工程指示 / 要求簡箋(E.I.)

工程指示編號：EI / 5524 / 22      修改版次：-  
 工程編號      : J - 858                      工程名稱      : 將軍澳日出康城  
 工程項目      : T2 幕牆單元件 廠用玻璃 BM 則師改倉 (204 件 + 8 件水缸位)  
 收件人         : 生統 / Maggie              發件人         : Ant Yeung              日期 : 21/12/2022

#### Revision on Curtain Wall Window Division

# Lohas P11 - Rectification of Curtain Wall Window Division between 2 Flats (1)

DWG NO. : J858-CW-PE210 REV. : G

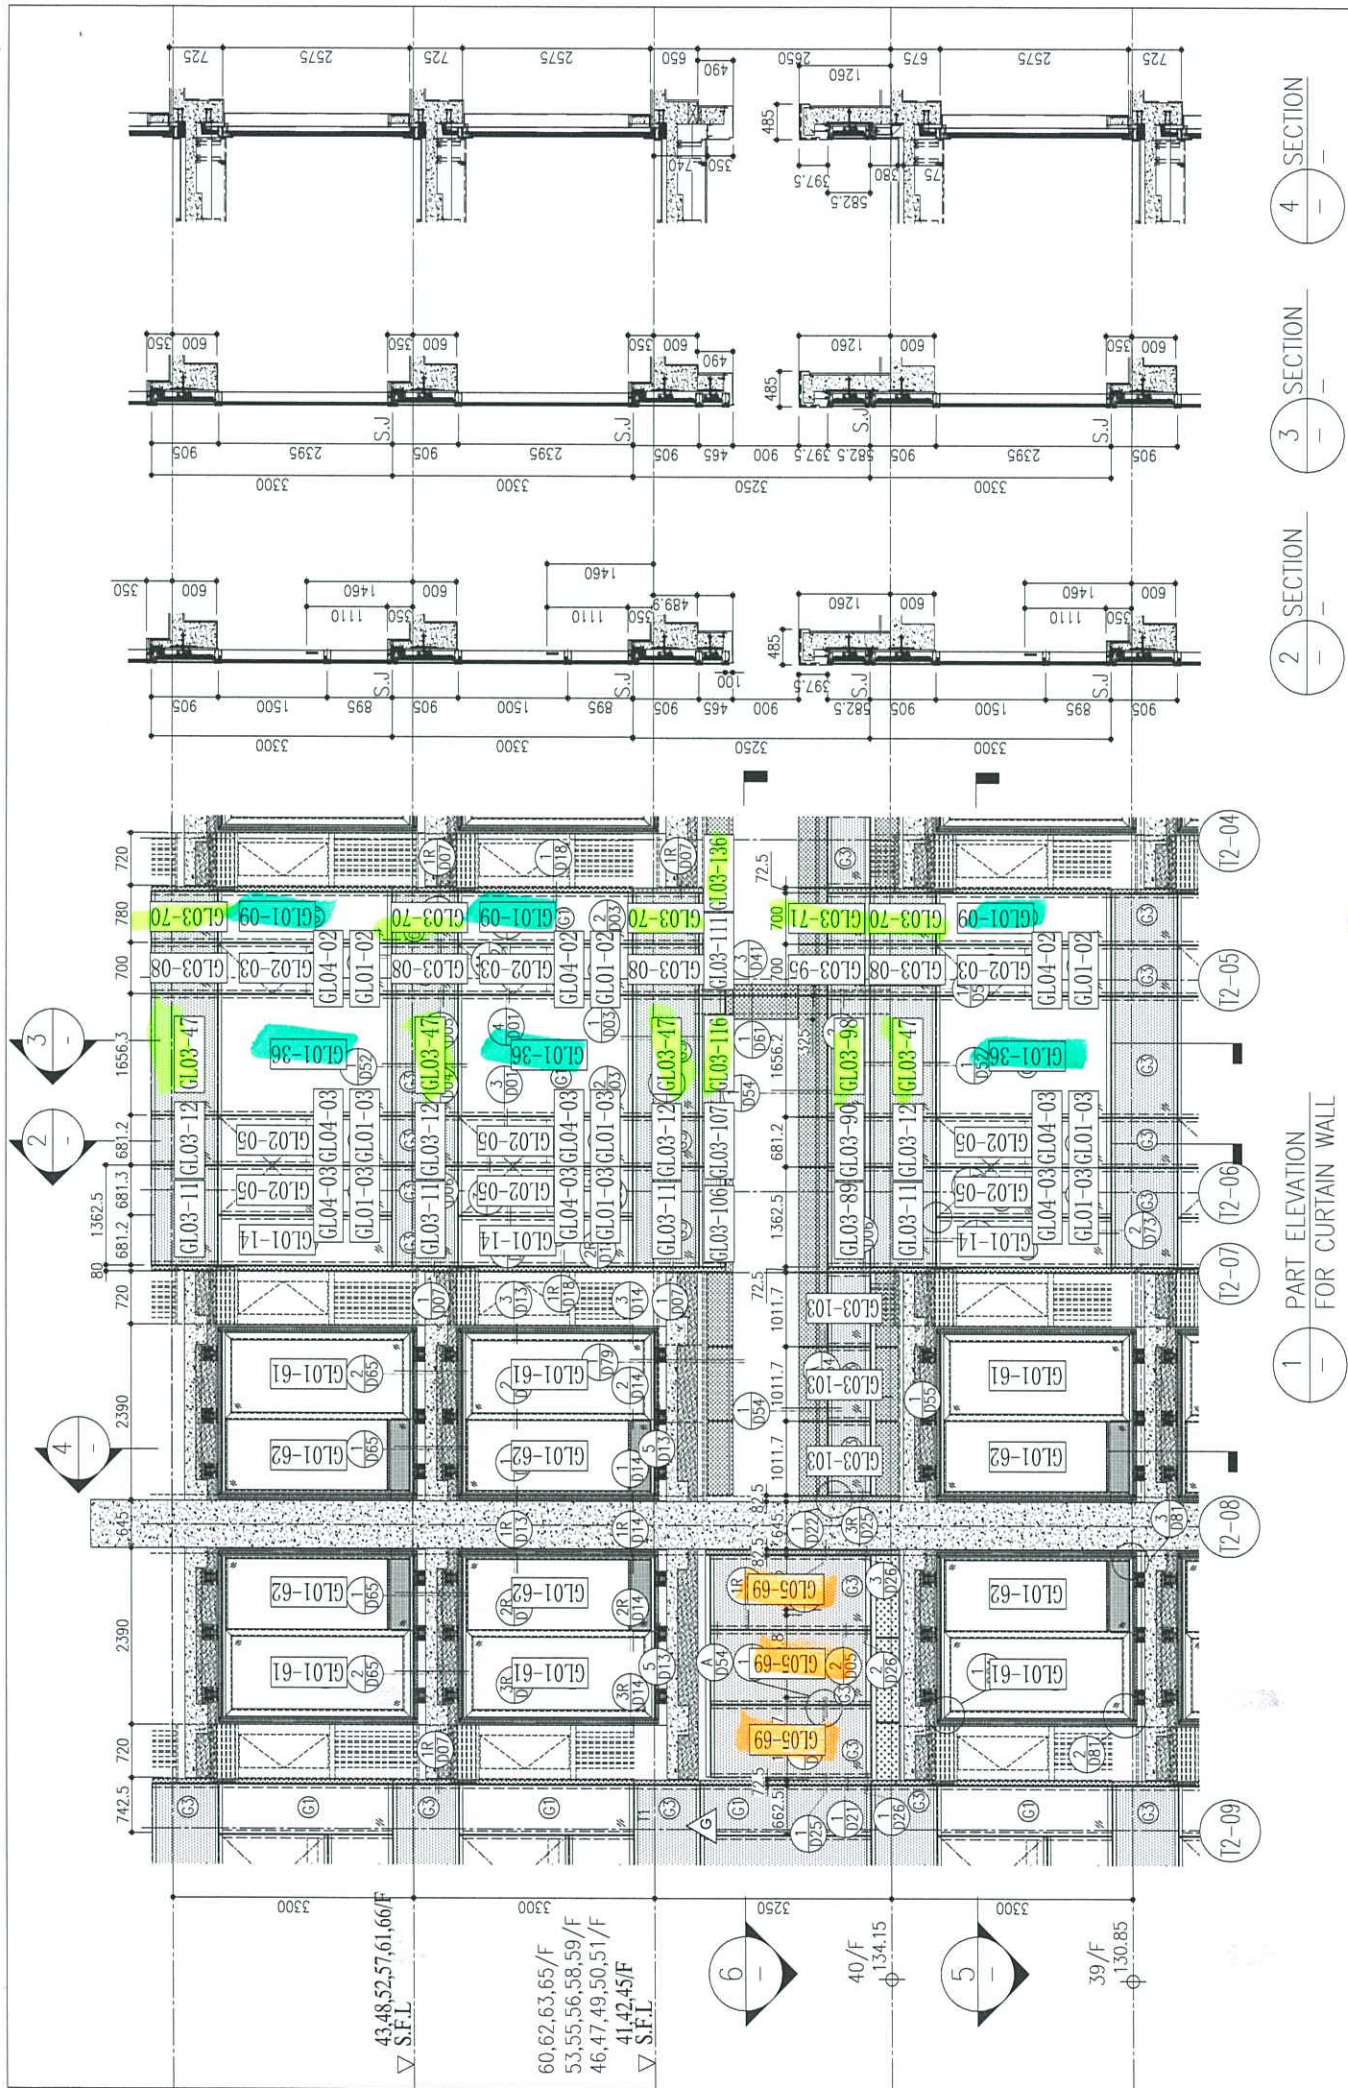
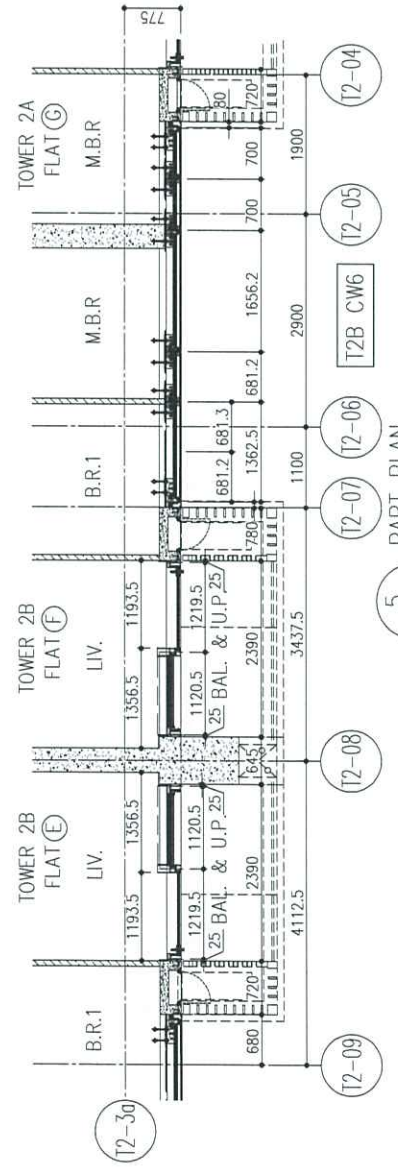
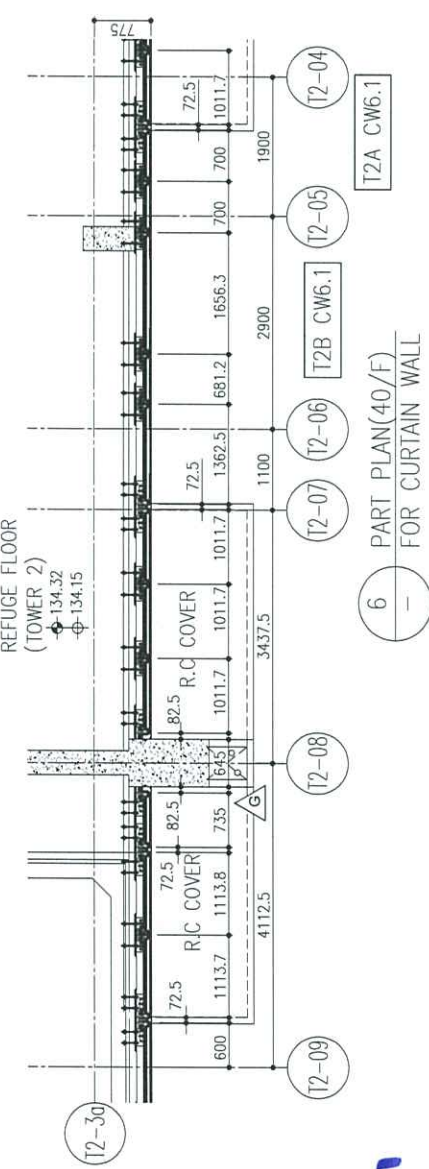
原 EI 4942 A : 因應則師修改尺寸 (AI-140) , 現給補回下單 204 件 \*\*優先出貨 9-17/F 用量  
加上早前剛剛確認位置的水缸位 8 件 11/F , 40/F

Pursuant to General Conditions of Contract Clause 11 and Special Condition of Contract SCC6, you are instructed to revise the division of curtain wall in between the following flat units to align with the centre line of structural wall in between the aforesaid flat units as per the drawing list attached:

Location	Floor Nos.
1.	T1A Flat G & T1B Flat F	9/F – 61/F
2.	T1A Flat C & Flat D	9/F – 62/F
3.	T2A Flat G & T2B Flat F	9/F – 66/F
4.	T3A Flat G & T3B Flat F	9/F – 66/F

J858康城11期单元幕墙玻璃分层统计表 (T2-9F~65F)

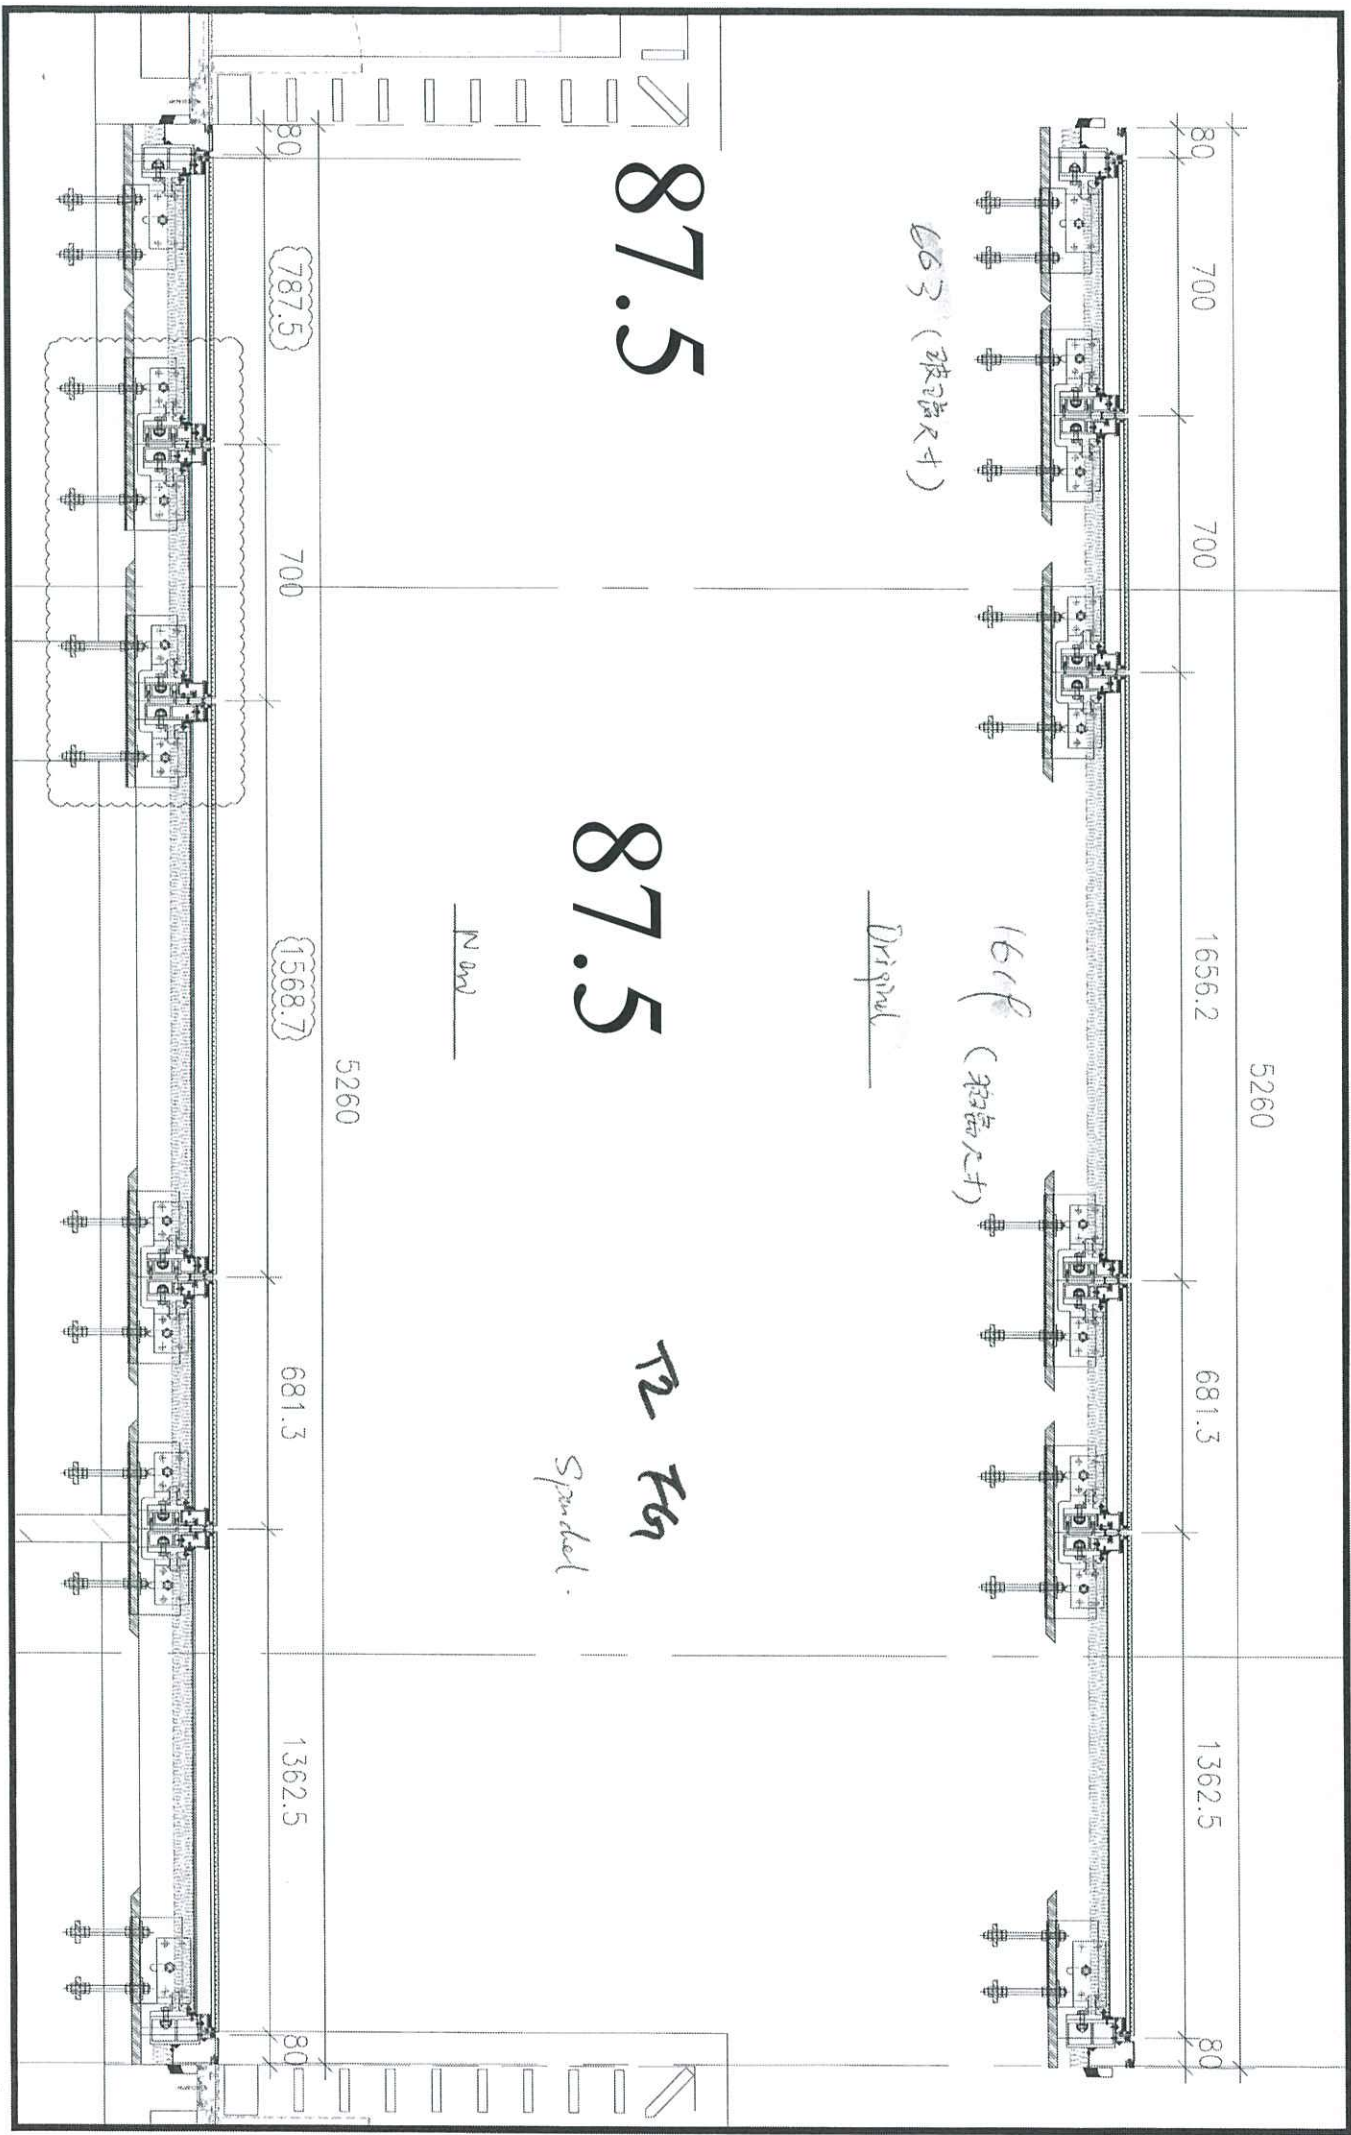
1619 (玻璃尺寸)

Original

1619 (玻璃尺寸)

only  
checking

修改OK  
新加

修改

水  
12月8号取消  
12月8号增加
